PROVIDENCE MEADOWS PSLR
LOCATION MAP

Re: **Providence Park West** PSLR Site Plan Narrative
Property south of Grand River west of Providence Parkway
Parcel Numbers 22-17-101-012 and 22-17-101-010
Novi, MI

Re: **Providence Meadows JZ26-0030 with ZMA 18.754** MPZ Narrative
Property south of Grand River west of Providence Parkway
Parcel Numbers 22-17-101-012 and 22-17-101-010
Novi, MI

Figure 1. City of Novi Regulated Woodlands Map

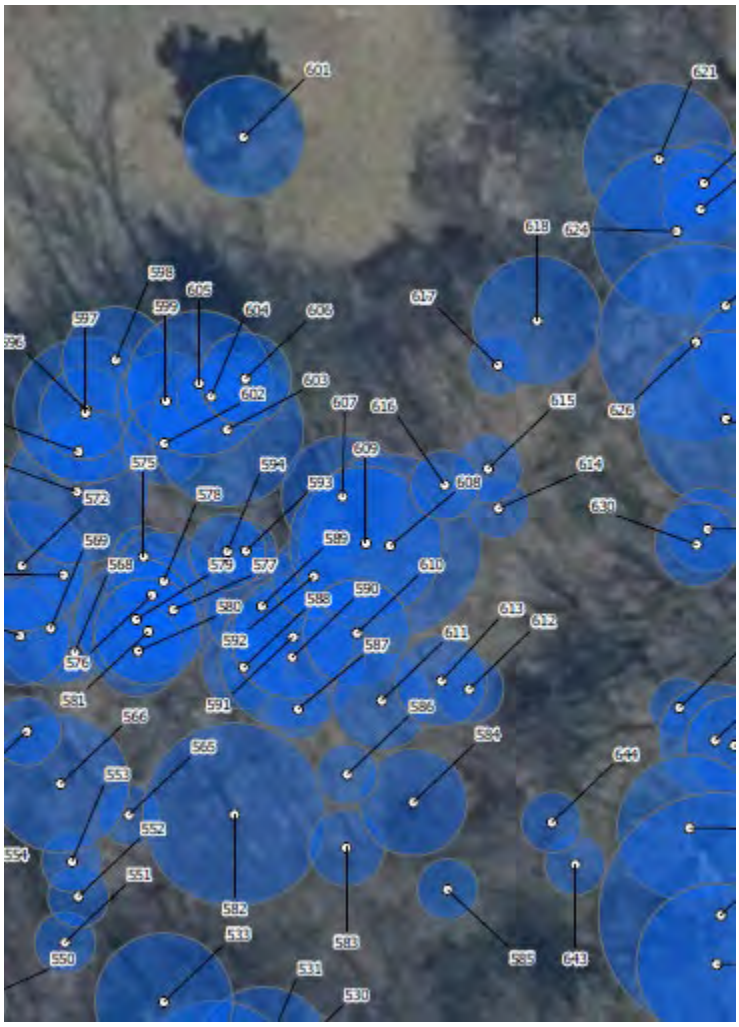
b. An updated outline of regulated woodland areas is provided in **Figure 1** and the shapefile (.shp) was provided to the City of Novi in previous reviews and can be provided to the applicant upon request. The regulated woodland area on-site is relatively consistent with the "Tree Line" and "Heavily Wooded Area" provided on Sheet C2 in the Site Plan.

Figure 2. City of Novi Regulated Wetlands Map
Approximate Site boundary is shown in Red.
Approximate Regulated Wetland areas are shown in blue.

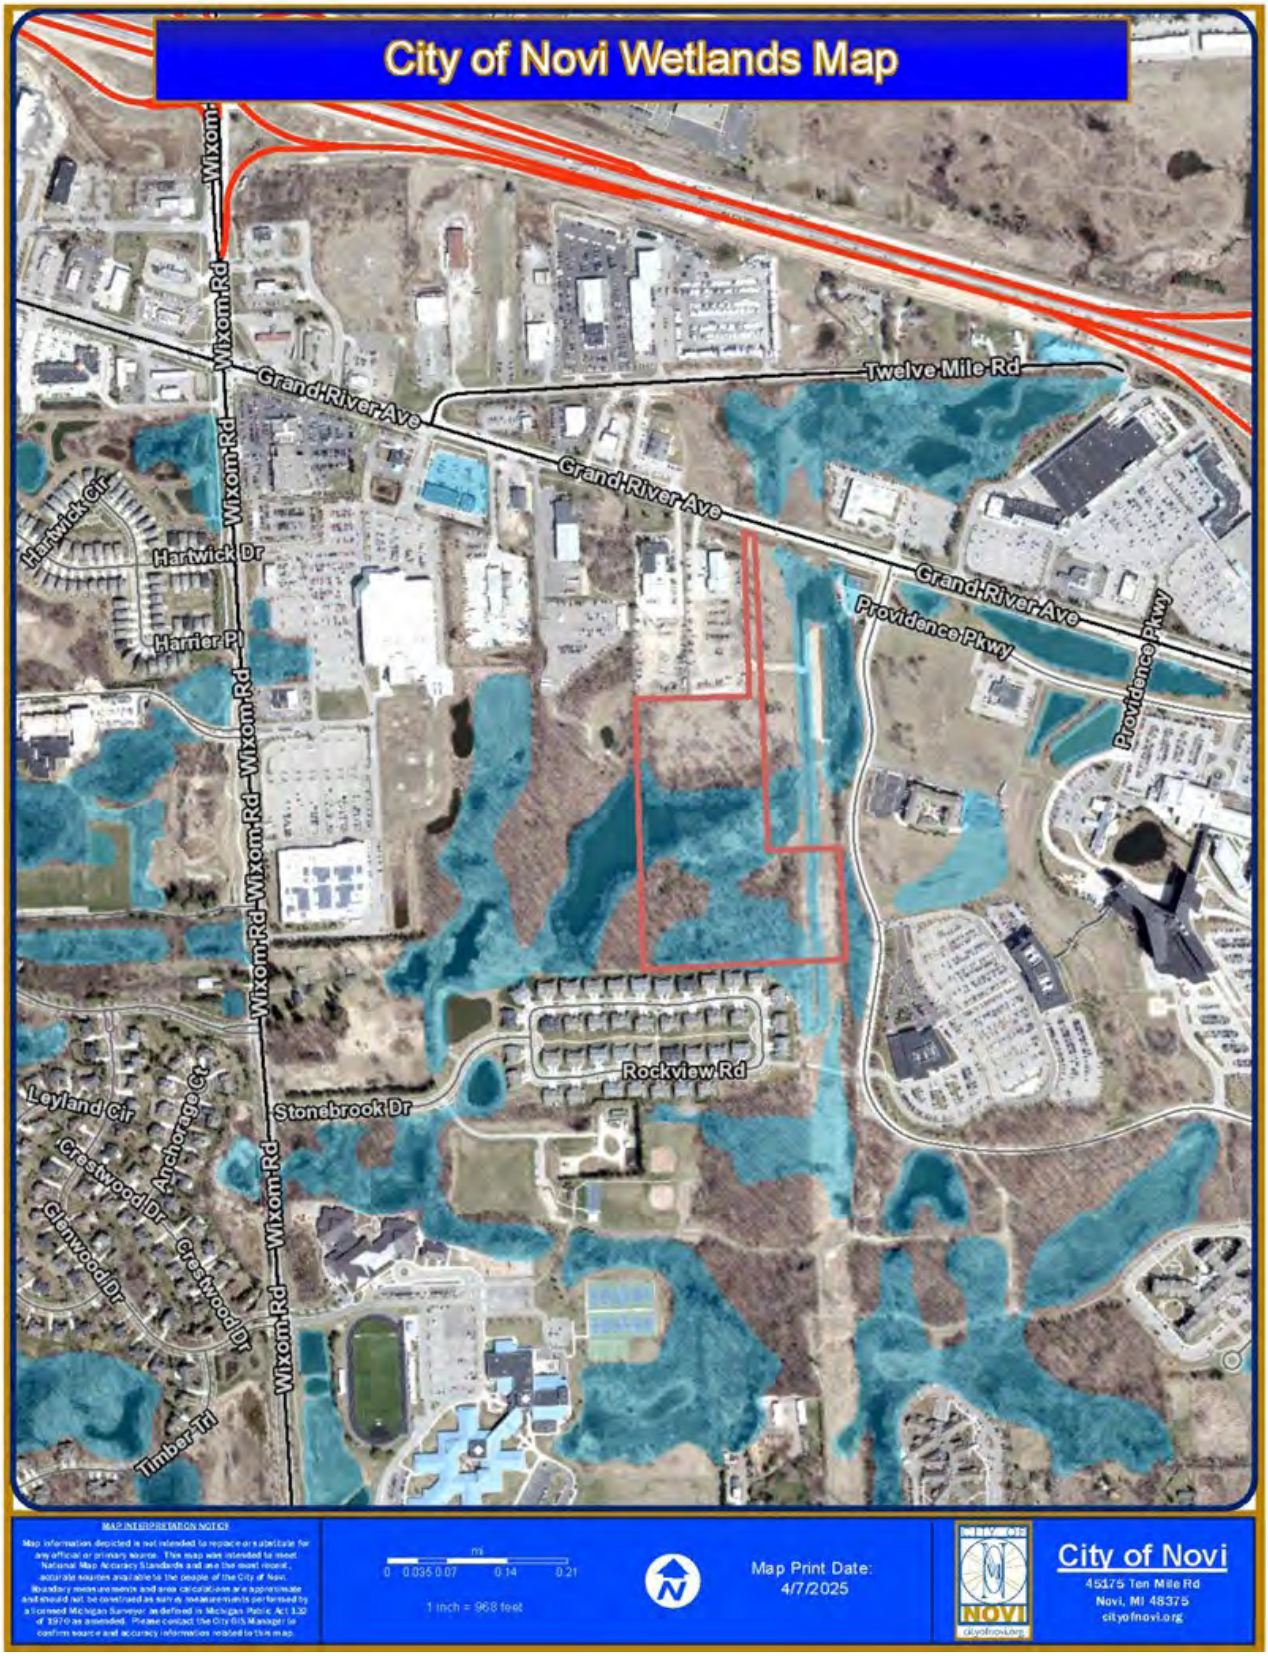
☒ City-regulated wetlands, as identified on the City of Novi interactive map website. Note that both wetland and property limits depicted on the City's map are considered approximations (**Figure 2**).
